PROJECT : COAL GASIFICATION BASED FERTILISER PLANT AT TALCHER, ODISHA
TENDER NO. : PNMM/PC-183/E-4006/NCB ELECTRICAL DISTRIBUTION SYSTEM
SUBJECT : REPLY TO PRE-BID QUERIES : LOT4 Dated 28.05.2021

TITLE : CONCEPTUAL FIRE WATER LAYOUT OF OSBL FACILITY FOR INTEGRATED COAL BASED FERTILIZER AND CHEMICALS COMPLEX

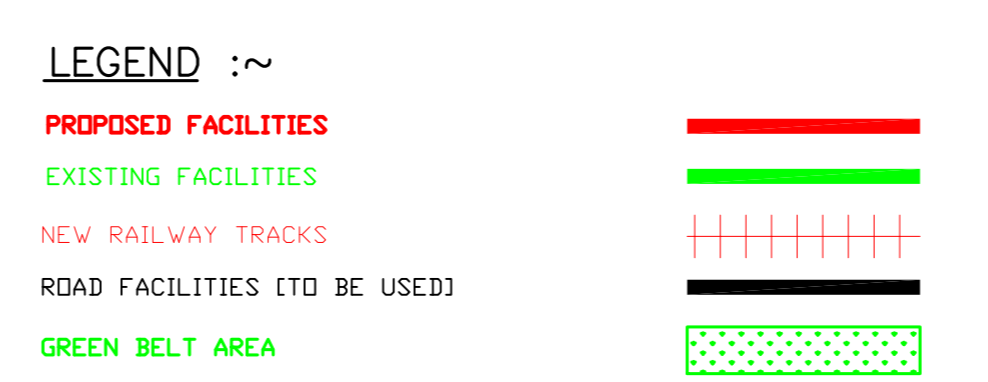
5.	Section : VI – 3.2.1, Fire Fighting System		Clause no. 3.5	Taping/s with the fire water mains shall be provided at plant battery limit (adjacent to the proposed plant location) as per requirement. The same (tie-in location/s) shall be decided during the detail engineering.	Kindly provide Existing Fire Pumping System Details (Capacity, Head, Qty)	Please find enclosed fire fighting layout for the complete plant. Tentative tie-in point for this package has been marked, other details as per NIT.

7.	Section : VI – 3.2.1, Fire Fighting System		Clause no. 3.5	Taping/s with the fire water mains shall be provided at plant battery limit (adjacent to the proposed plant location) as per requirement. The same (tie-in location/s) shall be decided during the detail engineering.	Please provide the Existing Fire Hydrant & Spray Piping layout drg showing Existing Fire Pipe header and tapping point which can be extended for HVWS & Hydrant system for MRSS & OUSS.	Please find enclosed fire fighting layout for the complete plant. Tentative tie-in point for this package has been marked, other details as per NIT.

8.	Section : VI – 3.2.1, Fire Fighting System		Clause no. 3.5	Taping/s with the fire water mains shall be provided at plant battery limit (adjacent to the proposed plant location) as per requirement. The same (tie-in	We are considering tapping distance from existing header as 50 metres. Please provide the exact length of tapping to be considered for the extension of Hydrant/ HVWS system.	Please find enclosed fire fighting layout for the complete plant. Tentative tie-in point for this package has been marked, other details as per NIT.
